For Official Use Only 請勿填寫此欄	Application No. 申請編號	A/YC-PH/1077
	Date Received 收到日期	2025-07-08

1. This Planning Statement is submitted to the Town Planning Board (“the Board”) on behalf of Mr. YIK King Kung Philip (“the Applicant”) in support of the planning application for ‘Proposed Temporary Warehouse (excluding Dangerous Goods Godown) with Ancillary Office and associated Filling of Land for a Period of 3 Years’ (“the Proposed Development”) on Lots 29 (Part), 33 (Part) and 35 (Part) in D.D. 111 and Adjoining Government Land, Pat Heung, Yuen Long (“the Site”) under Section 16 of the Town Planning Ordinance.

We would like to submit a response-to-comment, drainage proposal (Plans 6.1 and 6.2) and hydraulic calculations to respond to the comments from Transport Department, Drainage Services Department and Lands Department.

Plan 4a
(P 25025)

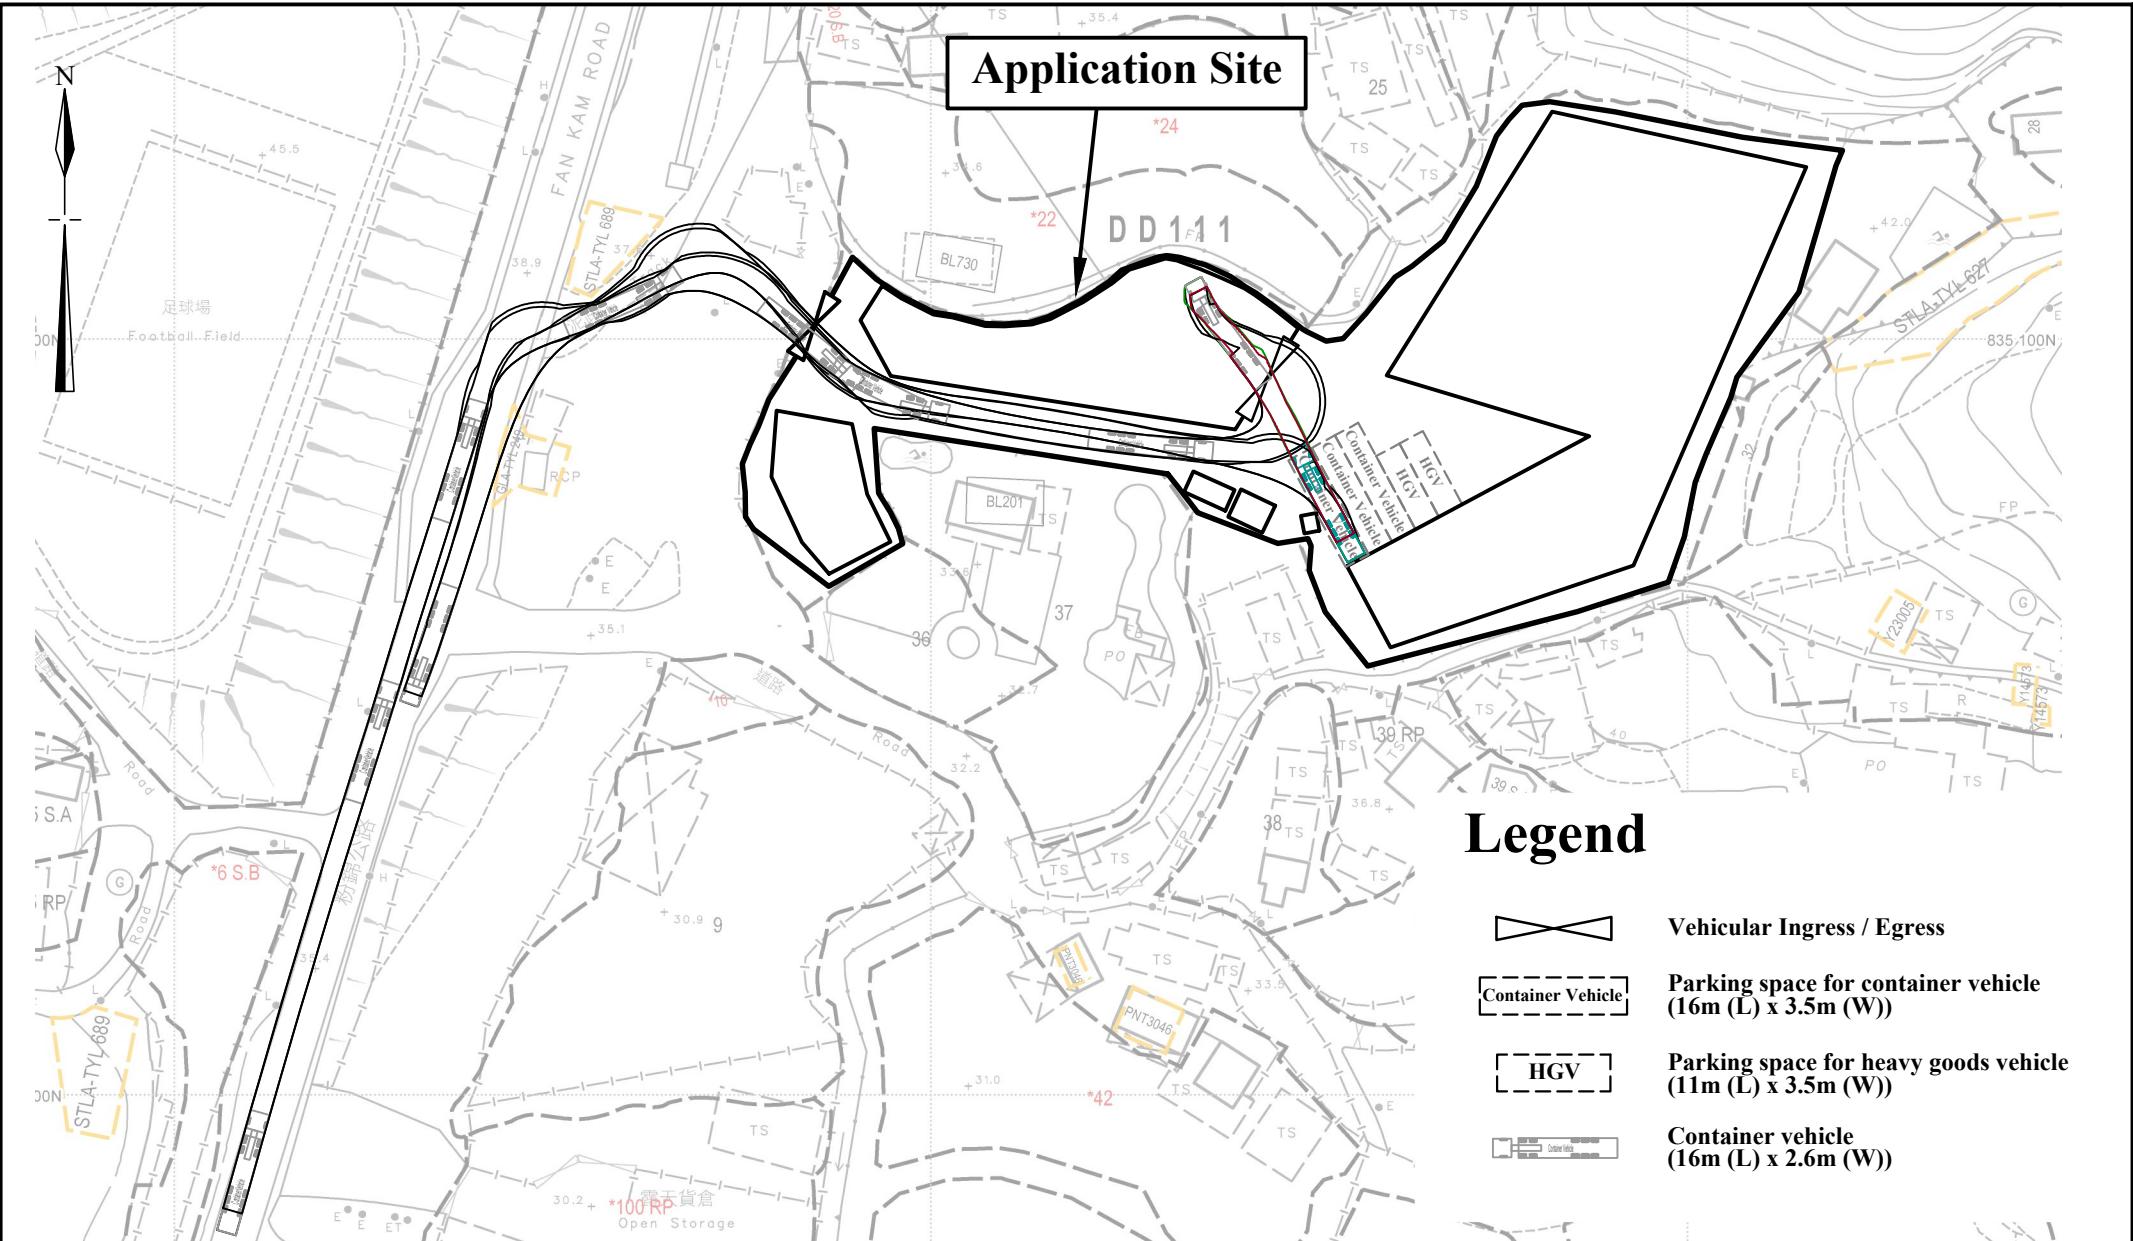
Comment	Response
<p>It is noted that container vehicles would access the site. Based on the swept path analysis, it requires a wide run-in/out so as to accommodate the turning movement. Please provide details of modification of run-in/out at footpath of Fan Kam Road accordingly.</p>	<p>The operator will inform container vehicle drivers that they must come to the site from northbound of Fan Kam Road and leave the site through southbound of Fan Kam Road.</p> <p>The operator will manage the traffic flow of the container vehicles. Container vehicles must make an appointment before they come. No two container vehicles will enter or leave the site at the same time.</p> <p>Please refer to updated Swept Path Analysis (Plan 4a) for details.</p>

Plan 6.1
(P 25025)

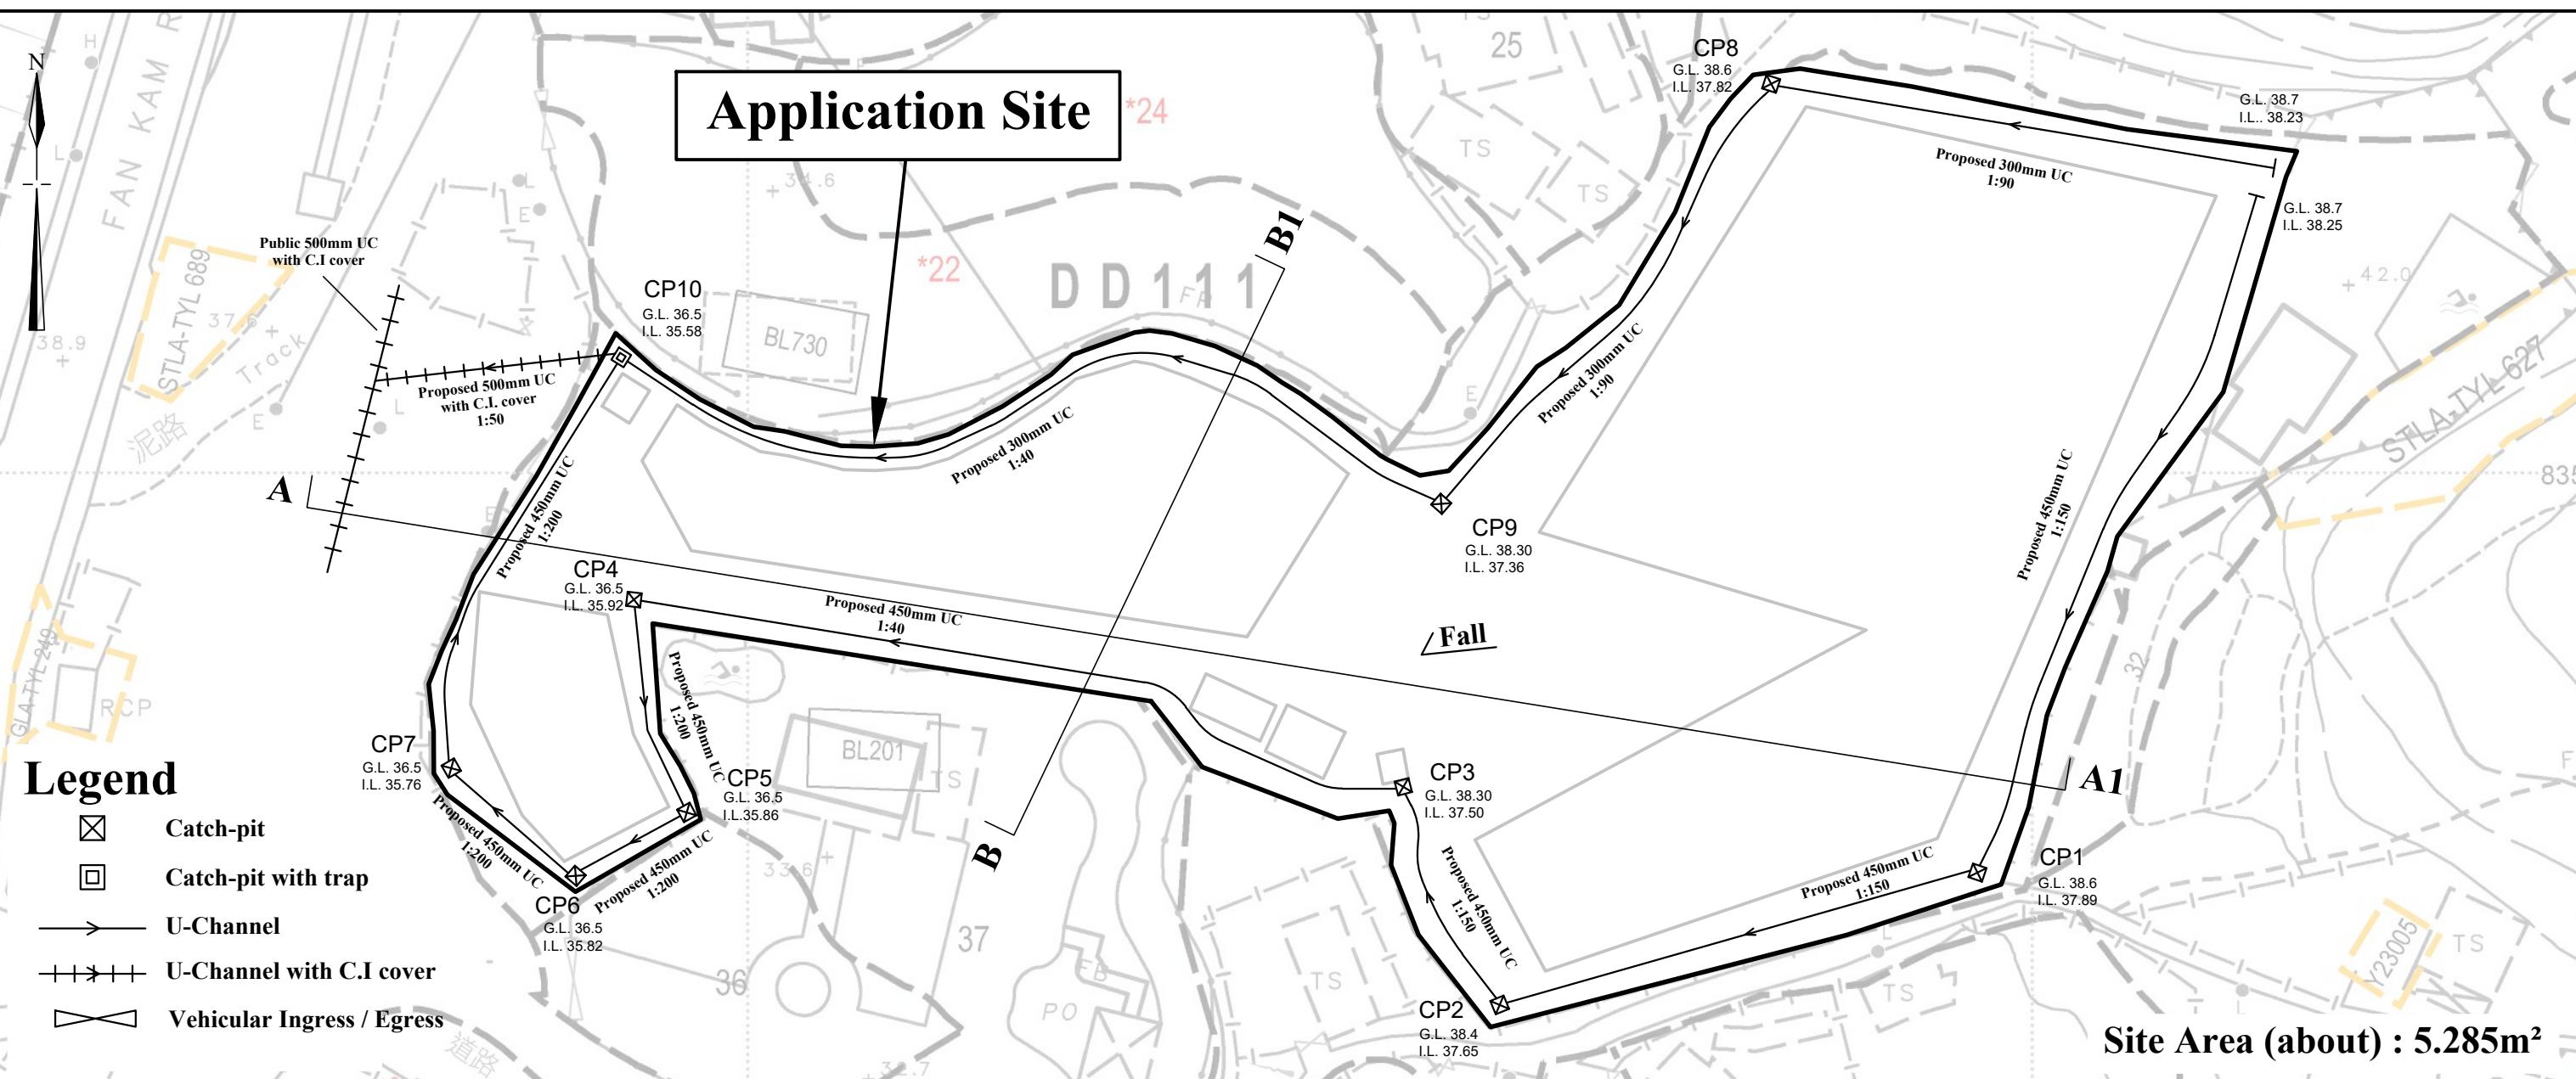
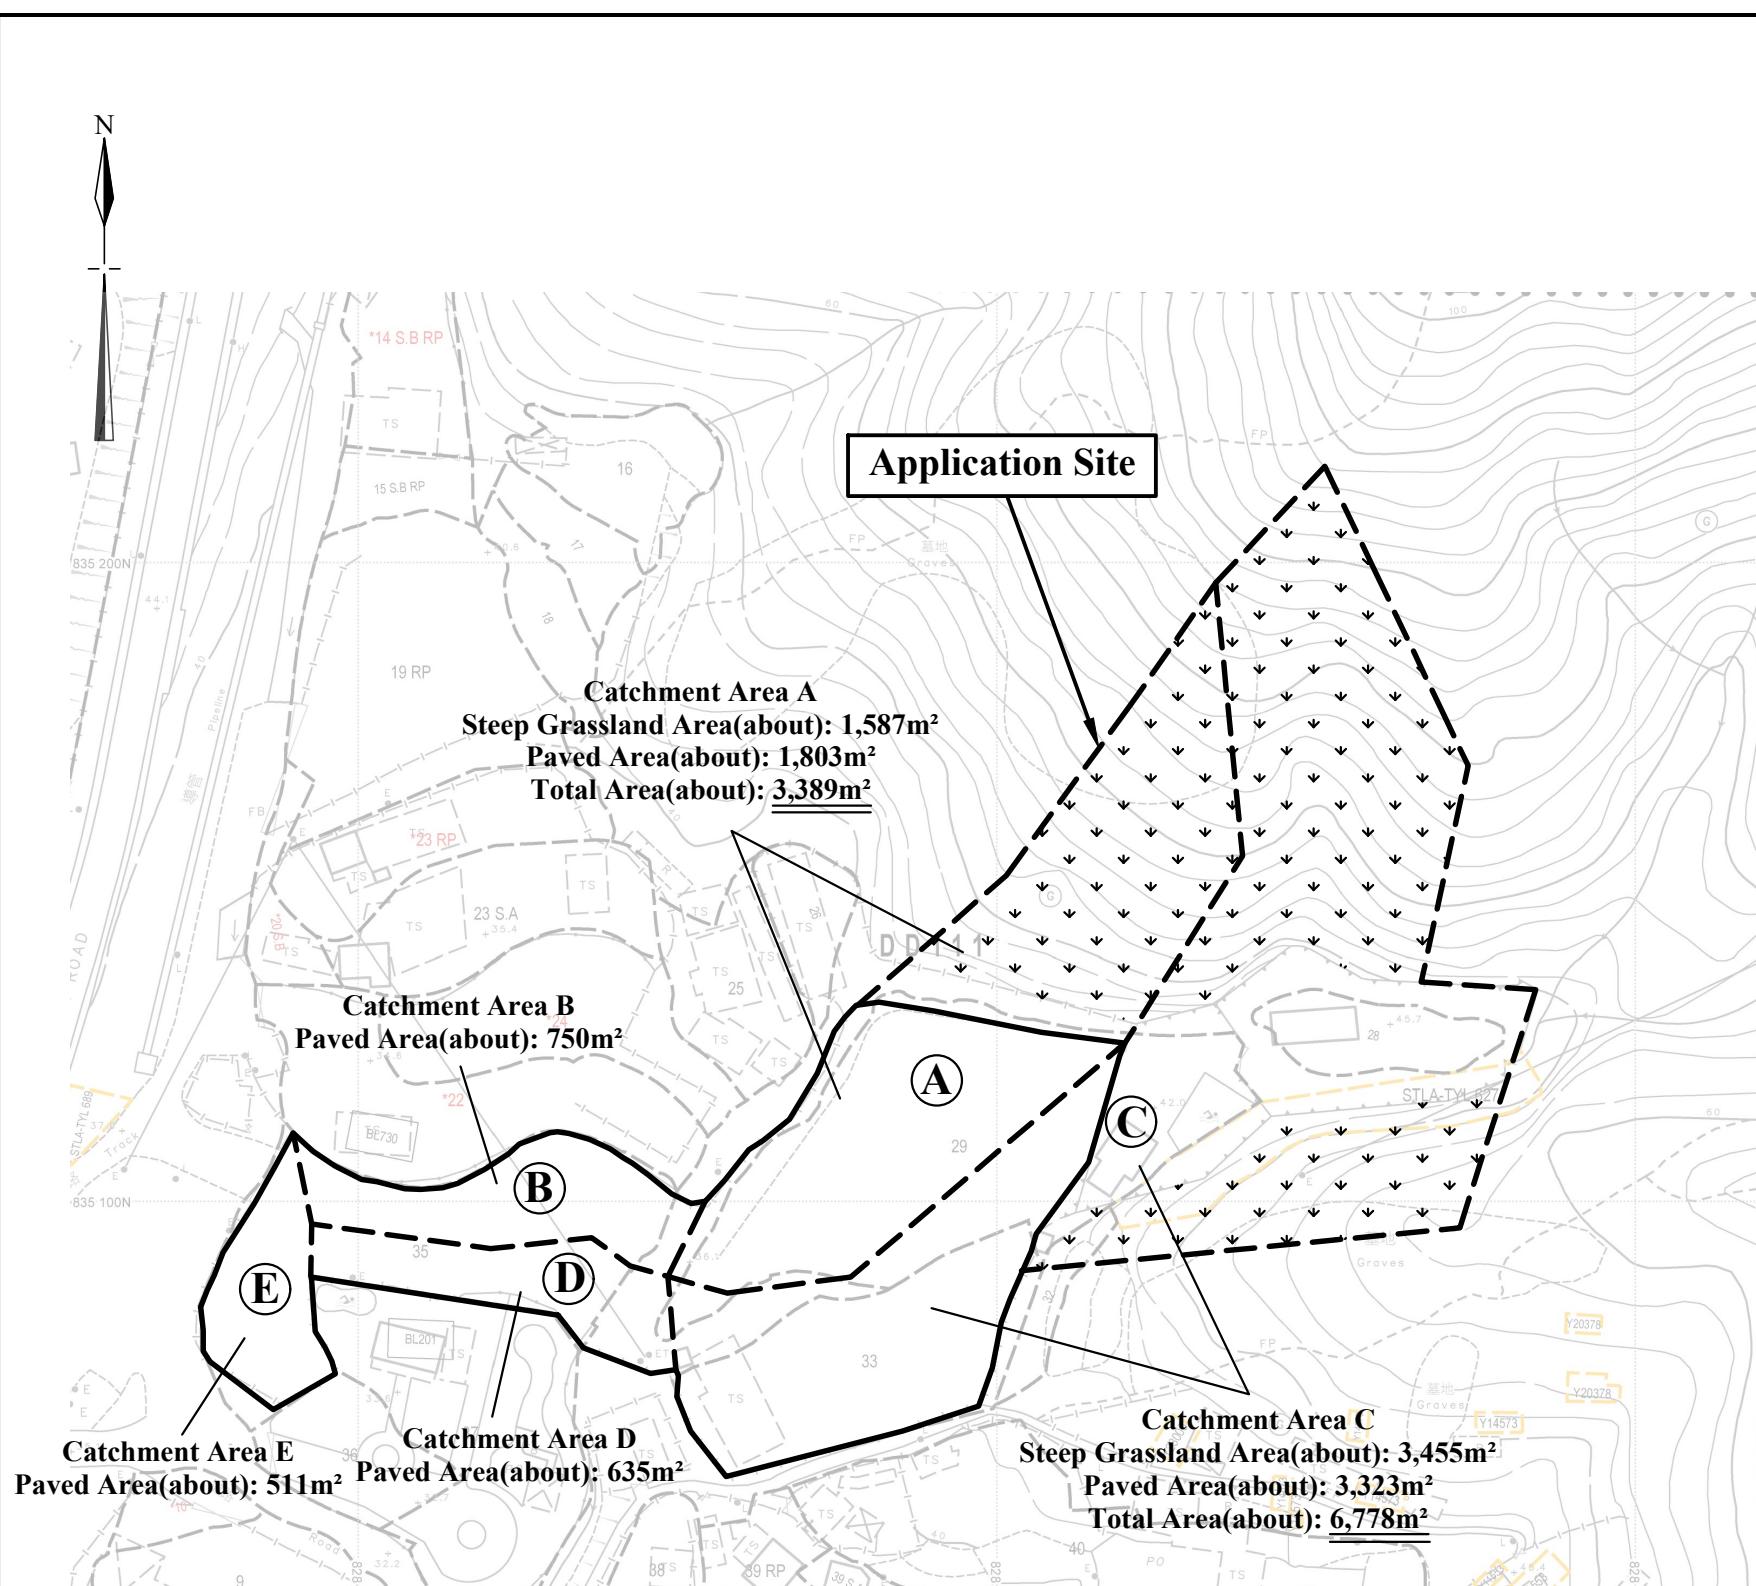
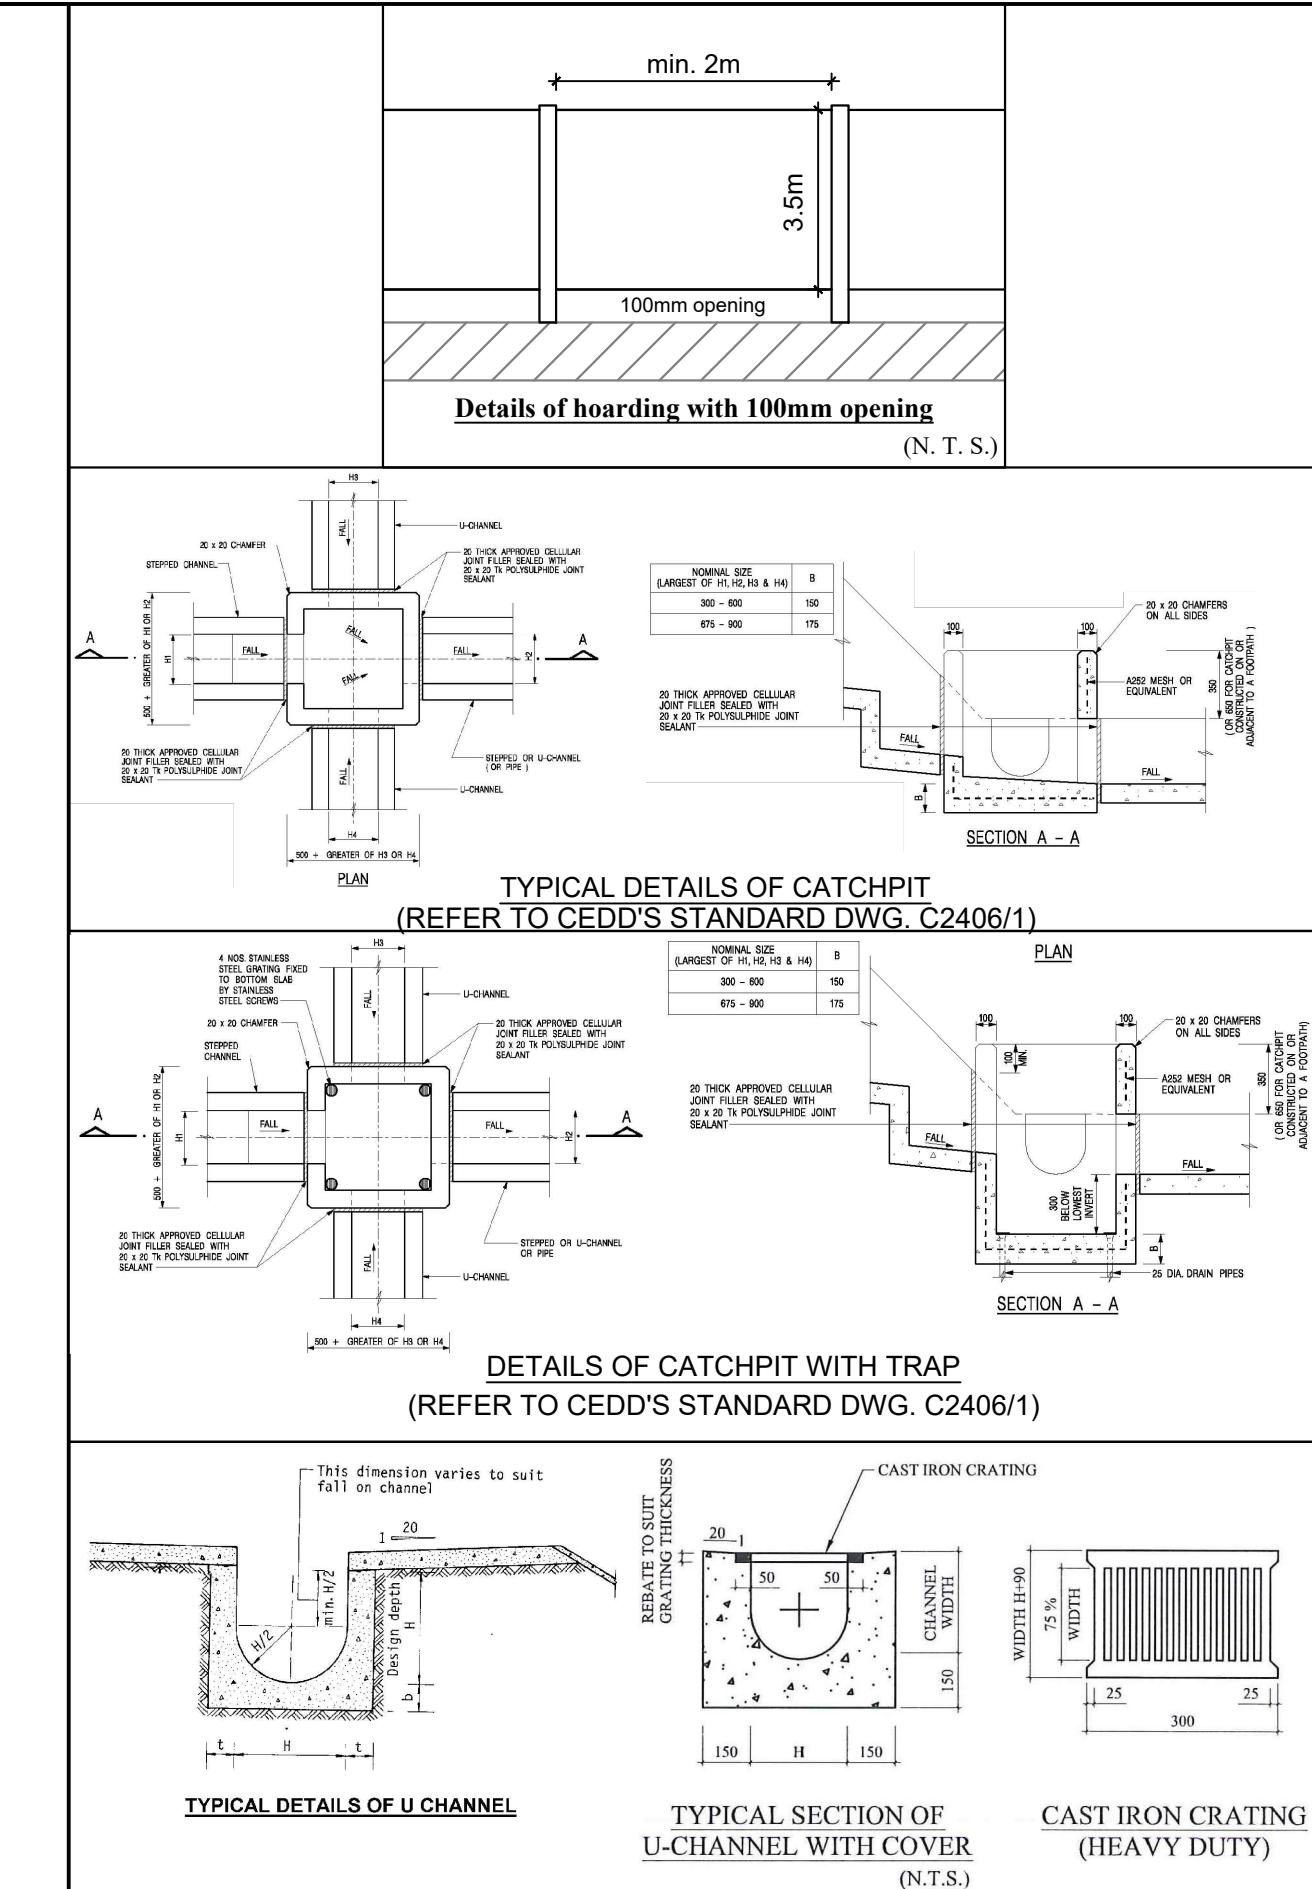
3.	We are unable to provide comment on drainage aspect of the application at this stage. Comment on drainage aspect will be provided when the drainage proposal as mentioned in paragraph 17 of the planning statement is received.	Please refer to attached drainage proposal for details.
